## CASE 16-23 – TESTIMONY IN OPPOSITION BY LAURA IVERS

TESTIMONY OF MICHAEL A. STOVER DATED JANUARY 25, 2018  
In ZC CASE 16-23 Valor Development LLC Square 1499

**Testimony of Sondra L. Mills in Opposition:**  
**ZC Case 16-23/Valor Development LLC/Square 1499**

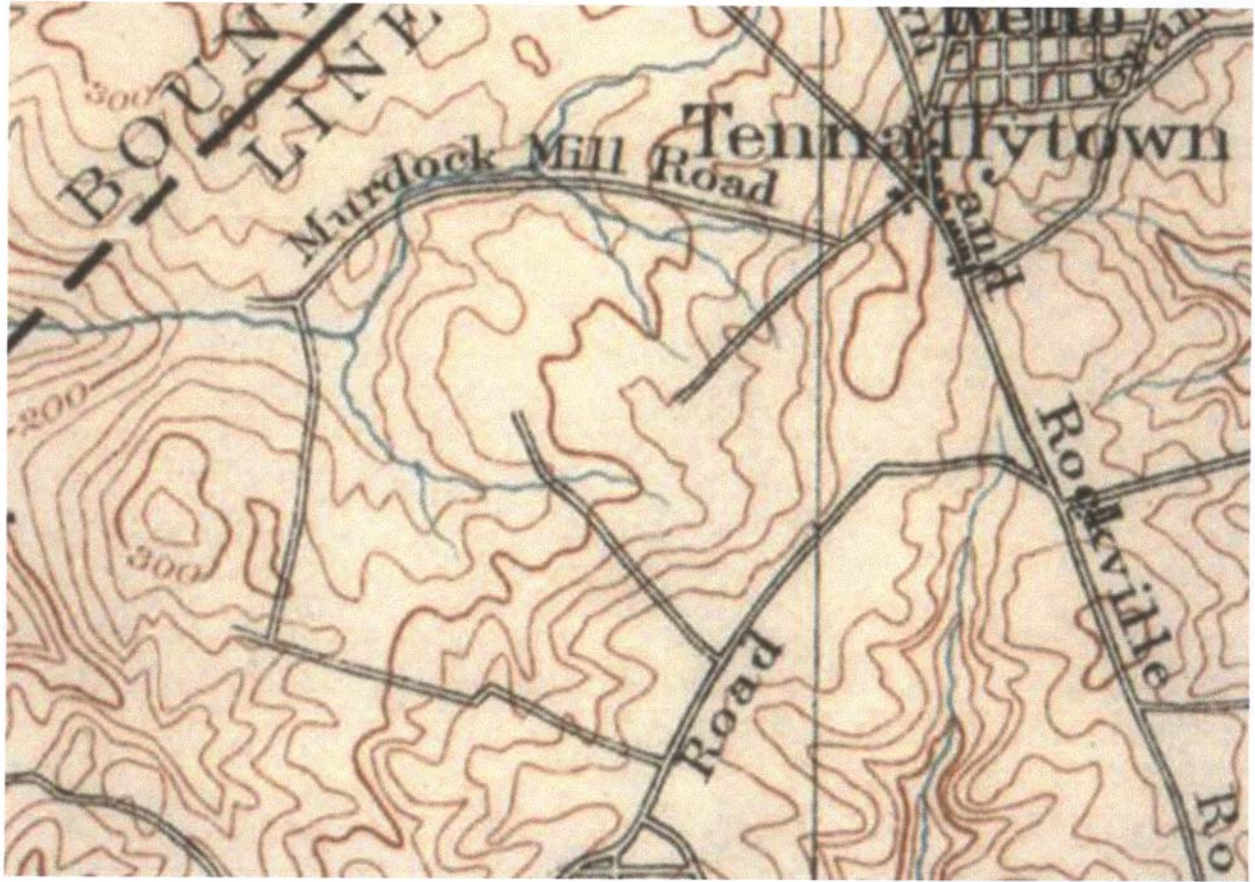
Furthermore, I would like to point out that the Office of Planning has made two serious errors in regard to the points I am making. In the first place, The Ladybird building is not "stepped down" in height along Yuma Street. Perhaps the OP is referring to the building's upper floor setbacks, but these are not **actual** reductions in height. As the Court of Appeals has ruled in the Durant case, such cosmetic features designed to mitigate the **impression** of height do not give the Commission a basis for deeming the building **less high than it actually is**.

1886 USGS Topographical Map of Washington D.C. (detail)

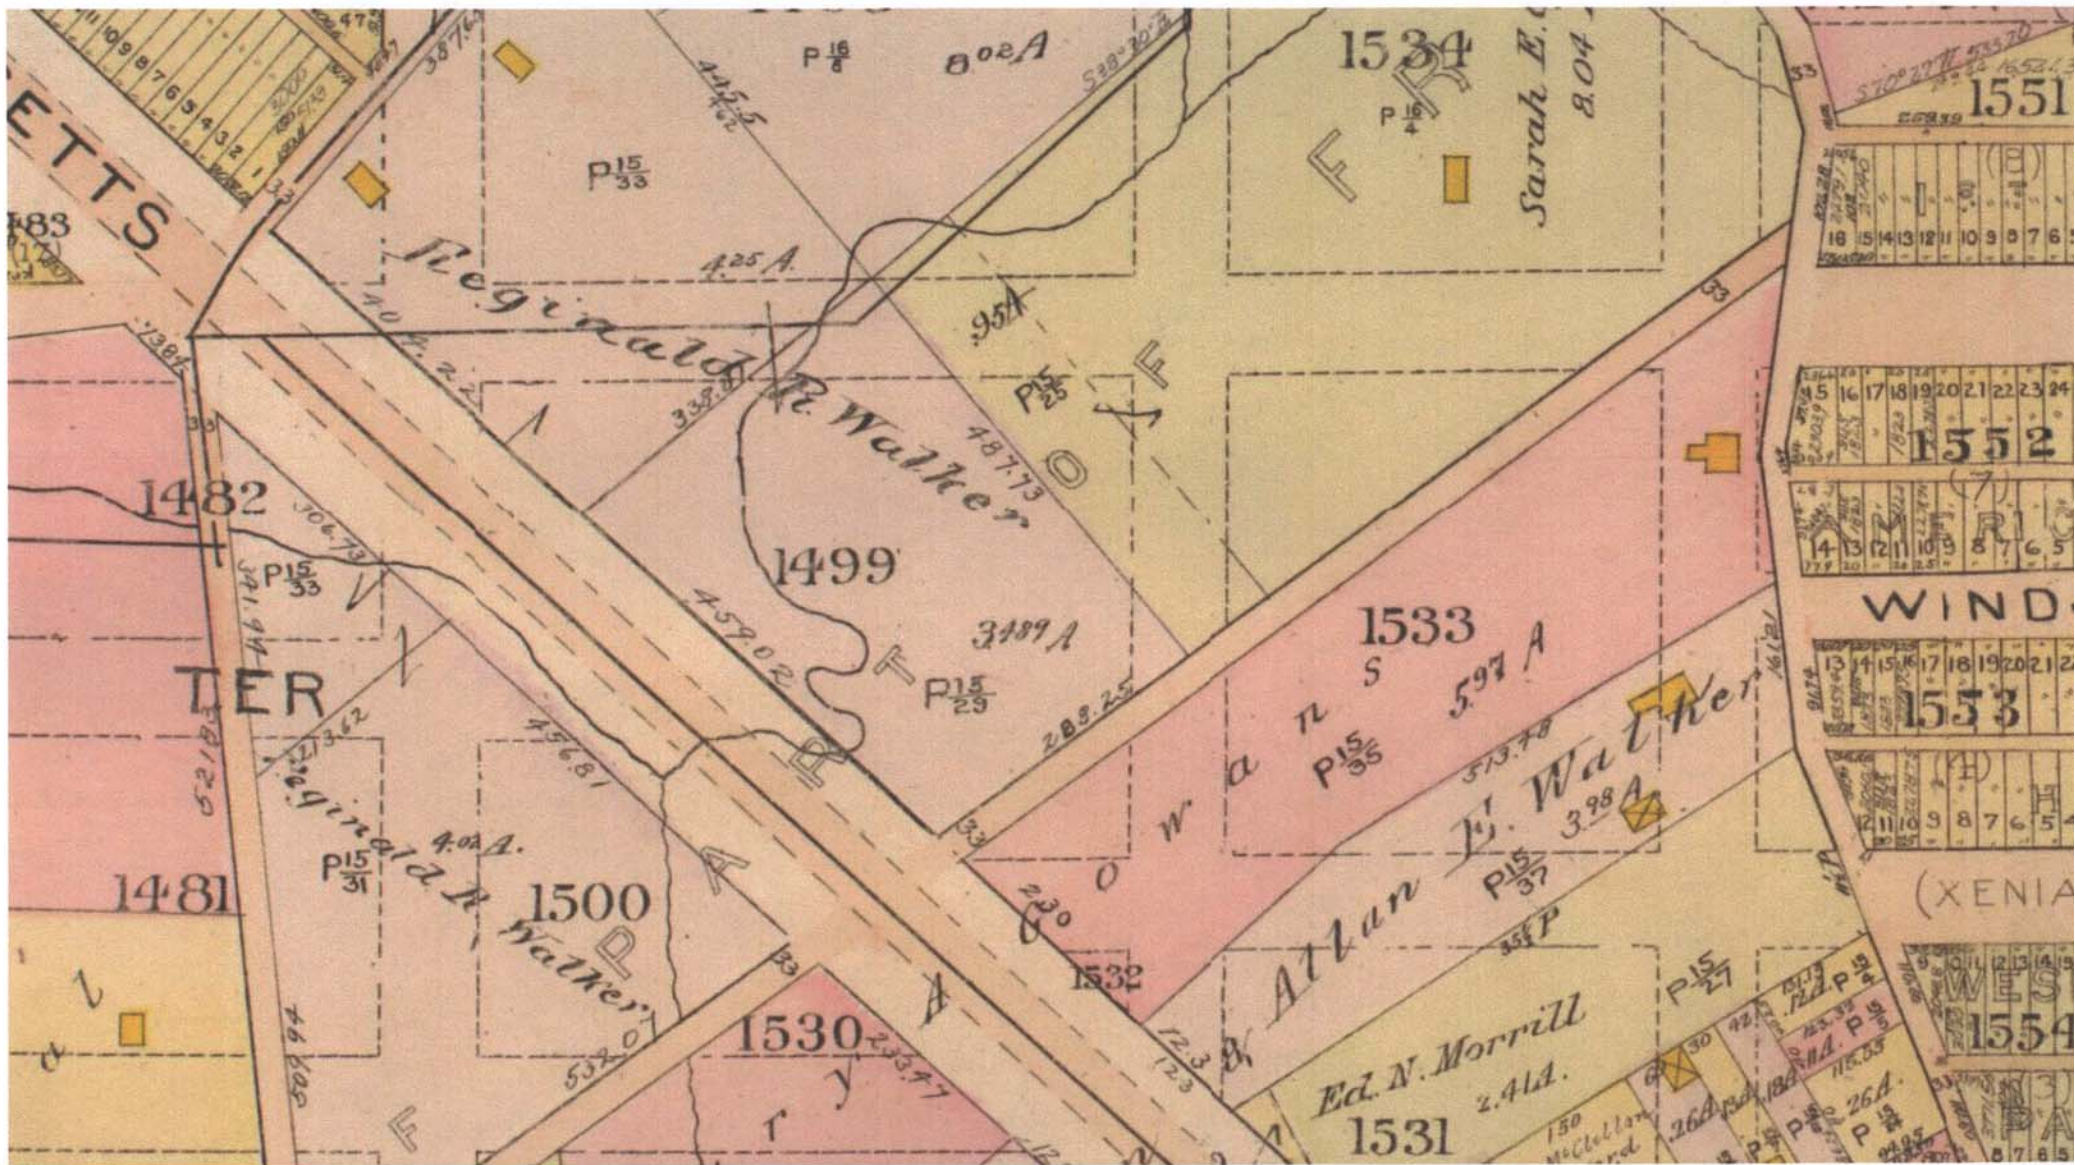
Valor has made a serious error in taking its 50-foot height measurement from the 48th Street side of its building because 48th Street rests upon an artificial embankment. This violates applicable zoning regulations. Valor is attempting to justify a massive structure that will rise impermissibly to 73 feet because (as Valor has admitted) this steeply sloping site, starting from that artificial embankment, drops 26 feet in elevation along Yuma Street.

From my observation of the topography, it is clear that the roadbed for 48th Street was leveled across the natural slope by building an artificial embankment on the downhill side, as illustrated by the diagram and photographs in the CRD Response. This conclusion is borne out by reference to the 1886 USGS topographic map (attached), which shows a continuous slope from above 48th Street down to what is now the SuperFresh lot. (You can get your bearings on this map by reference to the 1919 atlas map of D.C., also attached. Both maps show the location of Murdock Mill Creek at the bottom of the slope, which ran across Square 1499 - the SuperFresh site - as indicated on the 1919 map.) As you can see from the photographs, the 48th Street embankment levels the roadbed as well as the adjacent sidewalks and the lawn area with its trees. On the downhill side, the flat top of that embankment extends 24 feet from the 48th Street curb to the retaining wall. Just below that artificial embankment and retaining wall, there is a major excavation to accommodate the lower floor of the parking garage.

measurement **from the middle of the front of the building that faces Yuma Street**. That is the point required by Section 307.7 (c), because it is **not** affected by the embankment's artificial change in elevation. Alternatively, under Section 307.7 (d), the **Zoning Administrator** must determine an appropriate level based on the surrounding grid of shops and houses. (The lower floors of the Yuma Street side of the building are not, as Valor has disingenuously claimed, "below grade.") In sum, Valor failed to take due care, at the outset of their project, to determine if its design complied with the regulations of the Height Act. **Valor has not even addressed this problem, and has thus failed to meet its burden of proof.**
